HISTORIC AND DESIGN REVIEW COMMISSION

Agenda Item No: 16

HDRC CASE NO: 2015-102
ADDRESS: 511 ADAMS ST
LEGAL DESCRIPTION: NCB 2915 BLK 4 LOT 3
ZONING: RM4 H
CITY COUNCIL DIST.: 1
DISTRICT: King William Historic District
APPLICANT: Katherine Valadez/Eden Lawn & Landscape, LLC
OWNER: Lyle Wilson
TYPE OF WORK: Landscaping, turf removal
REQUEST:

SHEET DESCRIPTION:
Landscaping Plan:
Bed/Path Layout

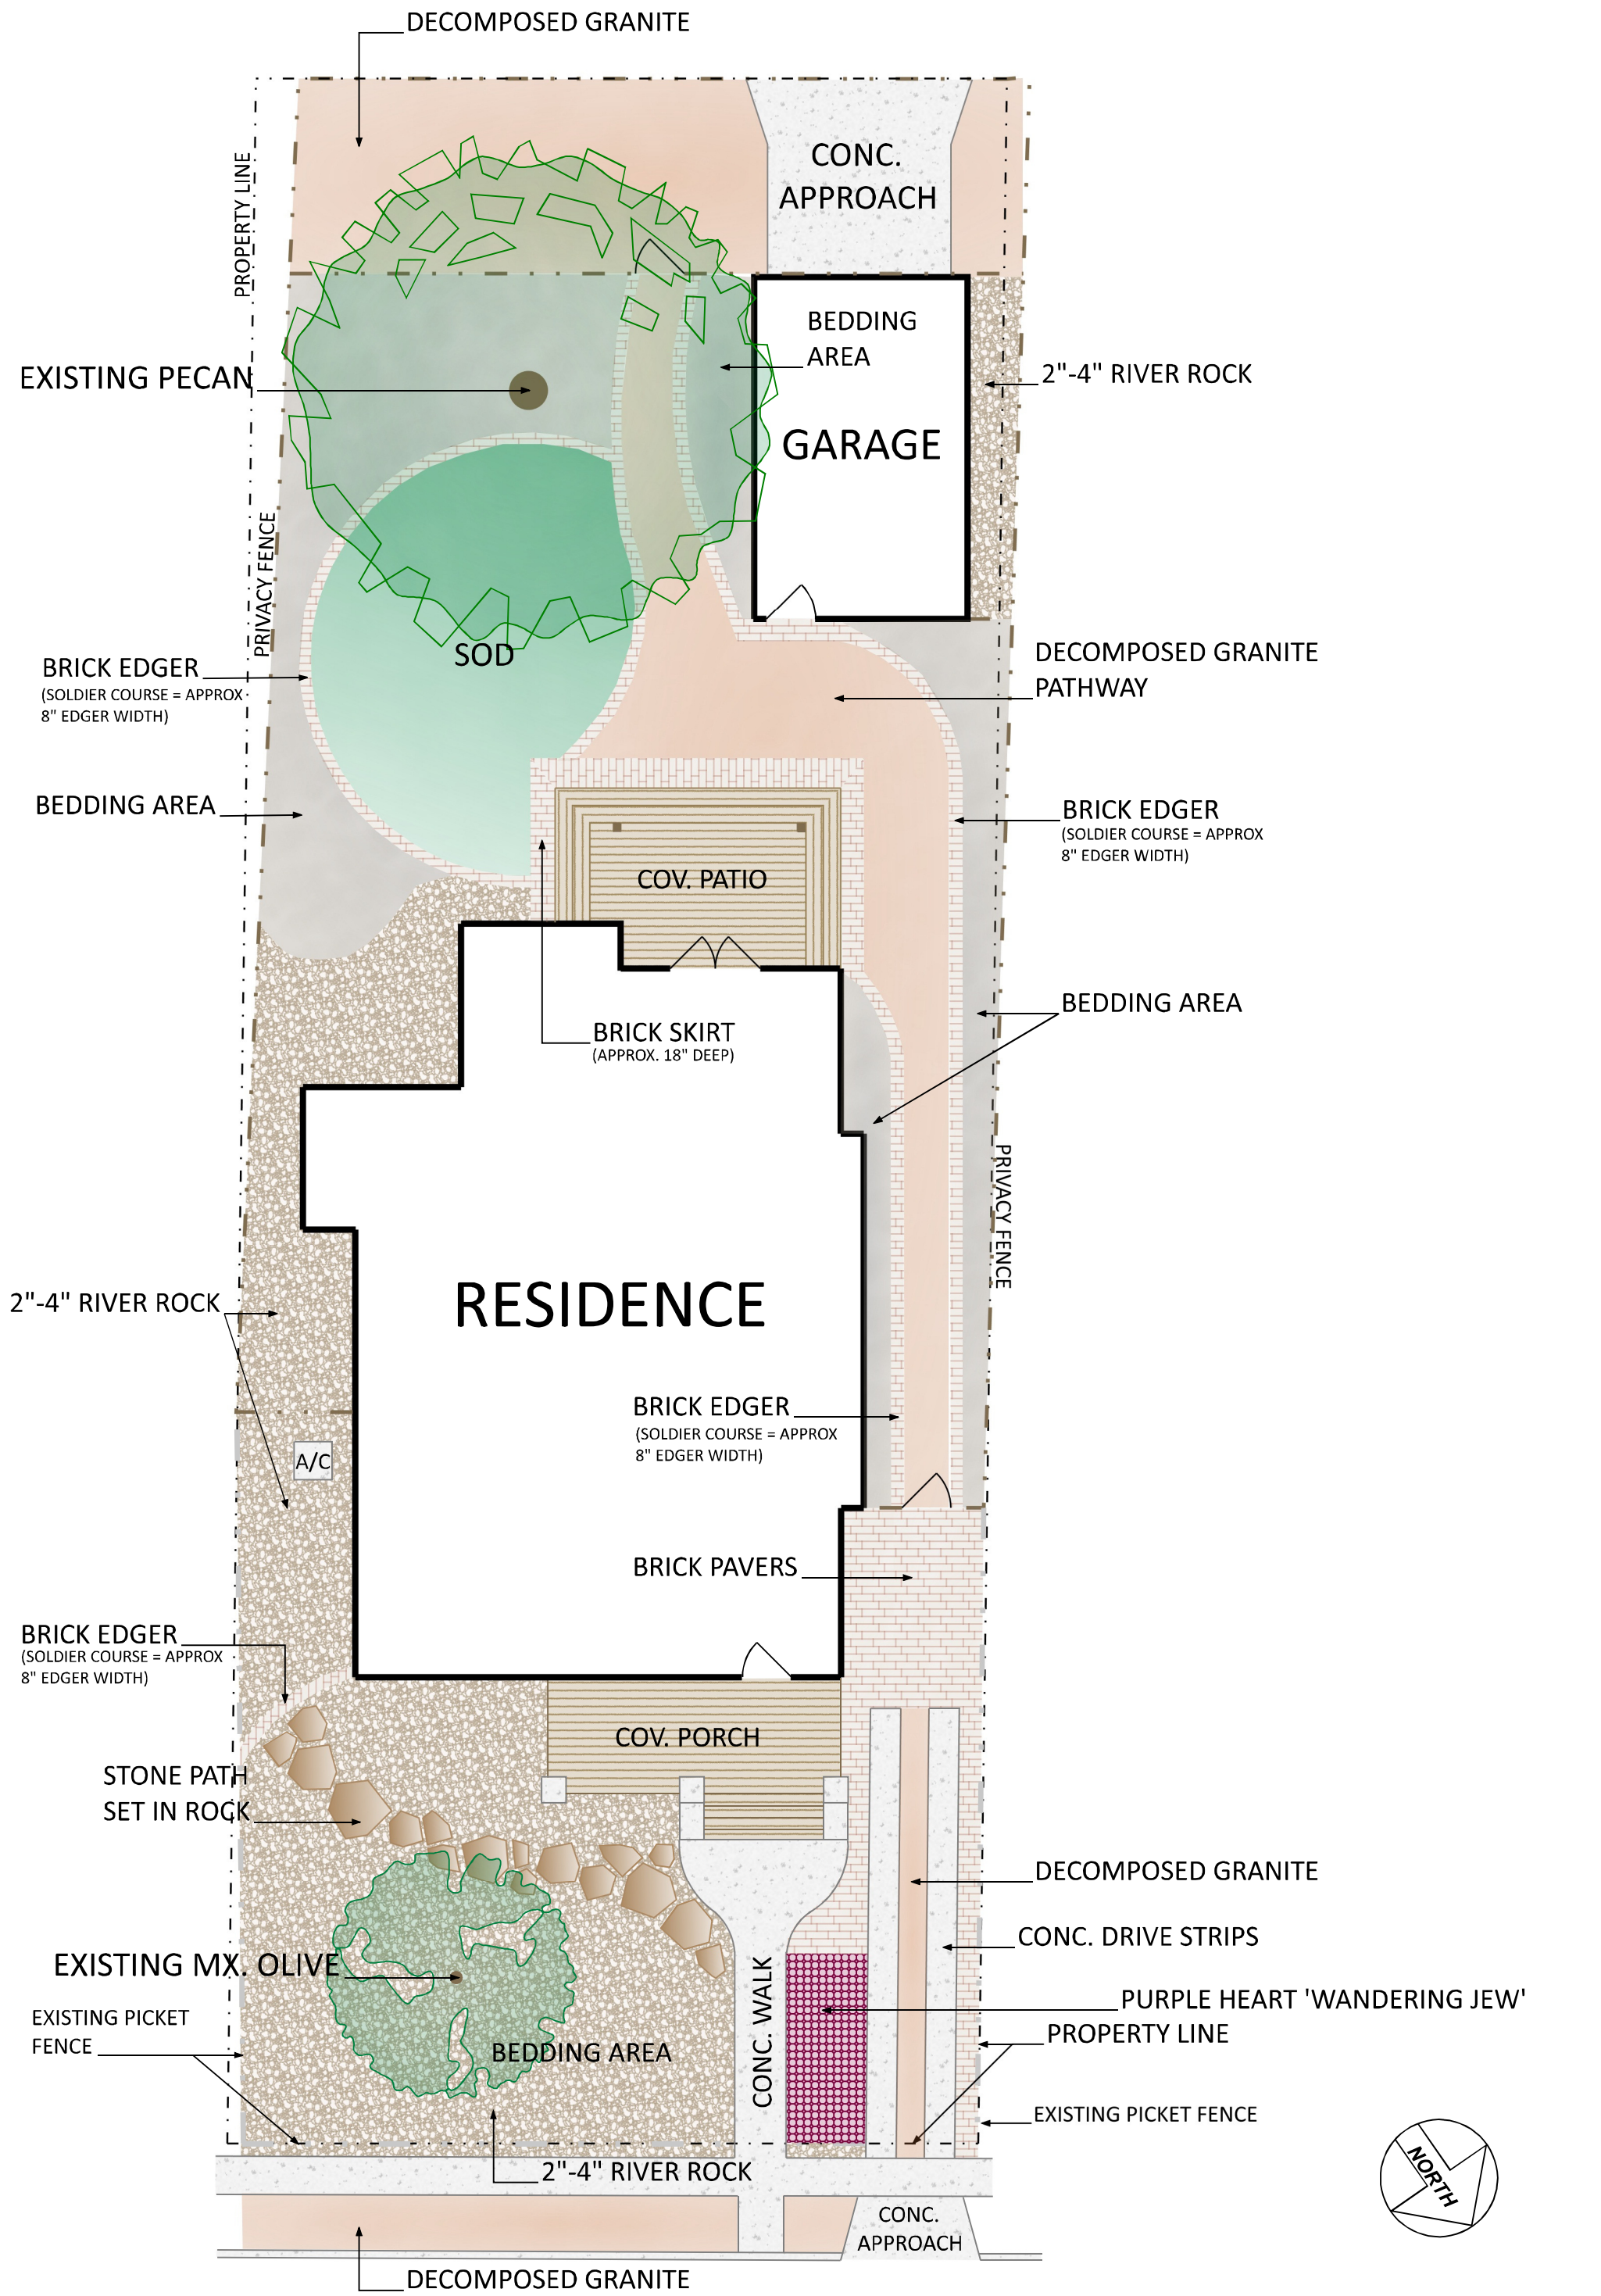
- a. The applicant has proposed various landscaping additions and modifications including the installation of an 8” brick edger, a decomposed granite pathway, multiple small bedding areas, the planting of purple heart, the installation of river rock, the creation of a circular sod area, the installation of bedding areas and the installation of a stone path. According to the Guidelines for Site Elements 3, low growing planting should be used in historic lawn areas, new pervious hardscapes should be limited to areas that are not highly visible and should incorporate small plantings into the design. The applicant’s proposal is consistent with the Guidelines for Site Elements 3.A. and 3.B.

- b. According to the Guidelines for Site Elements, historic lawn areas should never be reduced by more than 50% and rock mulch or gravel should not be used as a wholesale replacement for lawn areas. The applicant’s proposal to completely remove the front yard turf and rear yard turn south of the existing wood privacy fence bordering Wickes is not consistent with the Guidelines 3.A.ii. and 3.B.ii.

- c. The applicant has proposed to remove the existing sidewalk turf strip and replace it with decomposed granite. This is not consistent with the Guidelines for Site Elements 4.A.ii, which states that the use of traditional lawns in planting strips should be maintained in residential streetscapes.

Staff recommends approval of items #1 through #9 based on finding a.

Staff does not recommend approval of items #10 through #12 based on findings b and c.
